**From:** [Michael Behrendt](#)  
**Subject:** Main Street #19 - buffer to Urso property \*  
**Date:** Thursday, May 27, 2021 4:25:34 PM

As part of the site plan review for 19 Main Street the Planning Board will need to determine the acceptable landscaping, buffering, and screening (referred to below as "buffering") around the perimeter of the proposed parking lot. This is still under discussion and the landscaping plan will be revised soon following the change from retaining walls to sloping ground. I have raised this issue several times but will now make my recommendation for the buffer adjacent to the Urso property.

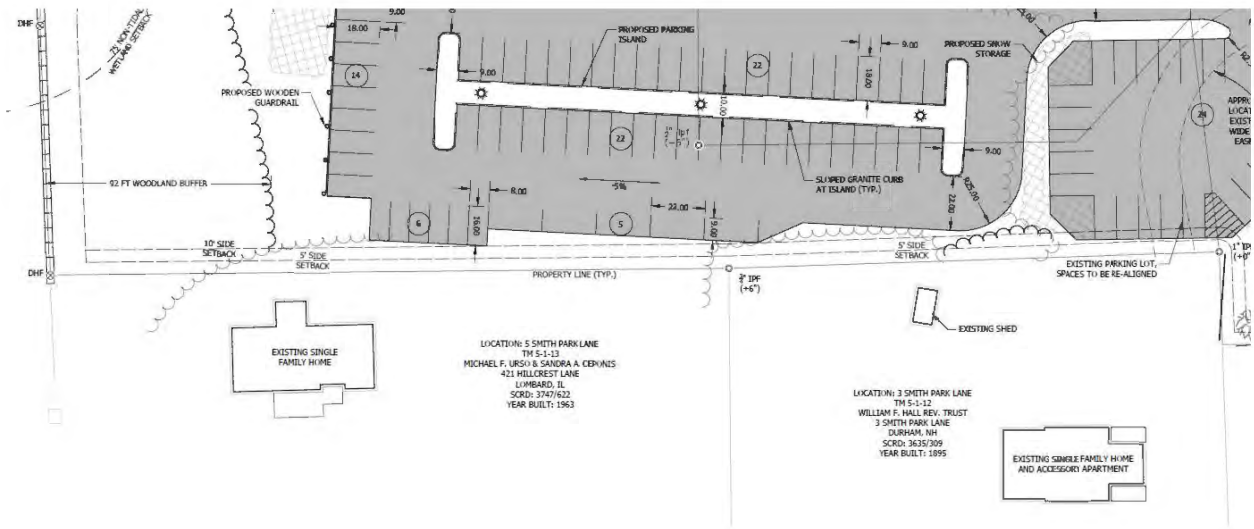
At the site walk yesterday I was struck by the proximity of the proposed parking lot to the Urso lot (a single-family property) – both the lot line and the house. This points to the value of site walks since one can discern only so much from two dimensional plans. *See the plans at the bottom.* The Urso property is on the left.

Arguably, the most fundamental concern in zoning is to protect single family houses from incompatible adjacent development. A strong buffer is called for adjacent to the Urso property. From my long experience in planning, here is the best practice that I have observed. **This is what I recommend to the Planning Board for the Urso buffer:**

- 1) A setback of the pavement/parking of 20 or 25 feet from the side lot line/rear lot line of the Urso property (Council Chambers is 25 feet wide.). It would be preferable to simply eliminate the 6 parking spaces facing the lot so there are no headlights pointing toward the house. The 5 parallel spaces could be removed allow for a straight side line and keep parked cars further from the Urso lot.
- 2) Installation of a 6-foot high fully opaque stockade fence at or near the side lot line (whether cedar or vinyl) with the finish side of the fence toward the abutter. The posts should be made of steel and set into concrete (or comparable).
- 3) Large, dense evergreen shrubs on the abutter's side of the fence (placed on the subject lot or the abutter's lot).

This kind of buffer is necessary and appropriate to separate a large parking lot from a single family house. The wholeness of the Urso lot should be maintained to the extent practical. Strong buffers include three elements: a decent horizontal setback (for lights, noise, and other impacts), vertical opacity (a fence), and vegetation to soften the fence.
